**Supplemental Information & Instructions  
for  
803-158 or 701560XPR Door Handle Set w/Locks  
TR 4 – 4A**

***Summary of Differences***

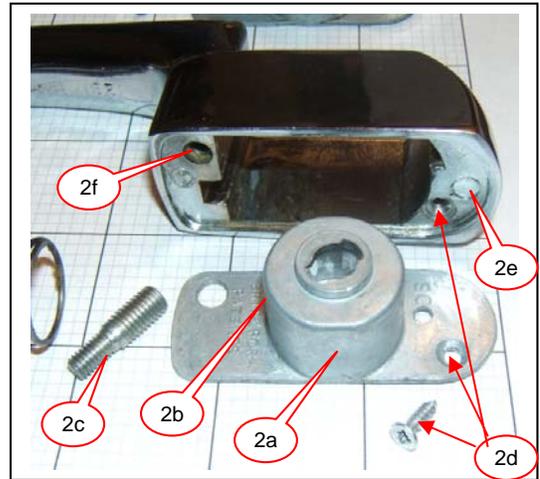
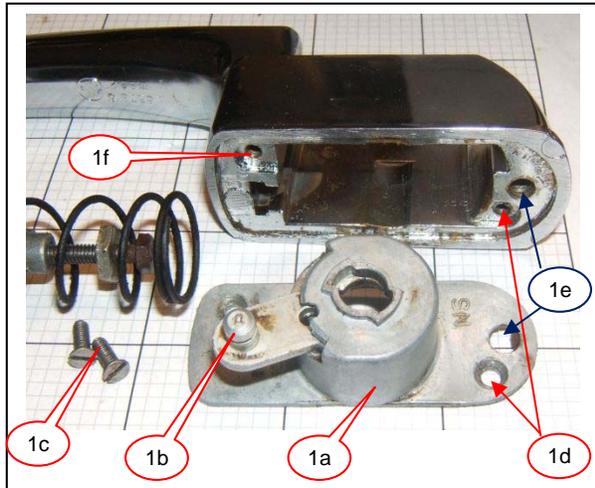
A-B The handle castings look virtually identical from the outside.

C-D-E The original actuating mechanism has the lever for the door lock; the replacement does not.

F-G The original actuating mechanism is attached with 2 screws; the new one uses 1 screw and 1 stud.

H-I The original push button and the replacement seem to be the same except for the keys. The replacement handles are sold as a set with matching keys, which is good.

The OE actuating mechanism (1a) has the all important pin (1b) for the lock connecting link. The replacement (2a,2b) does not, so it will be necessary to transfer the original assembly to the new handle if you want door locks. The original used 2 small countersunk screws (1c), and the new handle uses a stud (2c) that will interfere with the door lock lever (1b). The location of the original screw (1f) has a much larger hole (2f) in the new handle, which will probably mean that a new hole will have to be drilled for one of the original screws (1c). The other screw (1d, 2d) appears to be the same for both old and new handles. However, the front mounting screw (323-000) threads into a tapped hole (1e) which is missing (2e) so it will have to be drilled and tapped. This is necessary because the new handle was designed to use the stud (2c) which can't be used because it would interfere with the door lock actuating lever (1b). I suggest you spend some time with the factory workshop manual to see how the linkage bits attach to the handle. This paragraph has everything we know about the handle so far, but there may be issues that we don't know about yet.

At the other end of the handle, the difference is simple – the original handle was tapped for a 323-000 10-32 slotted screw. The new handle has a stud. At this time we are unaware of any problems using the stud with a nut instead of a screw.
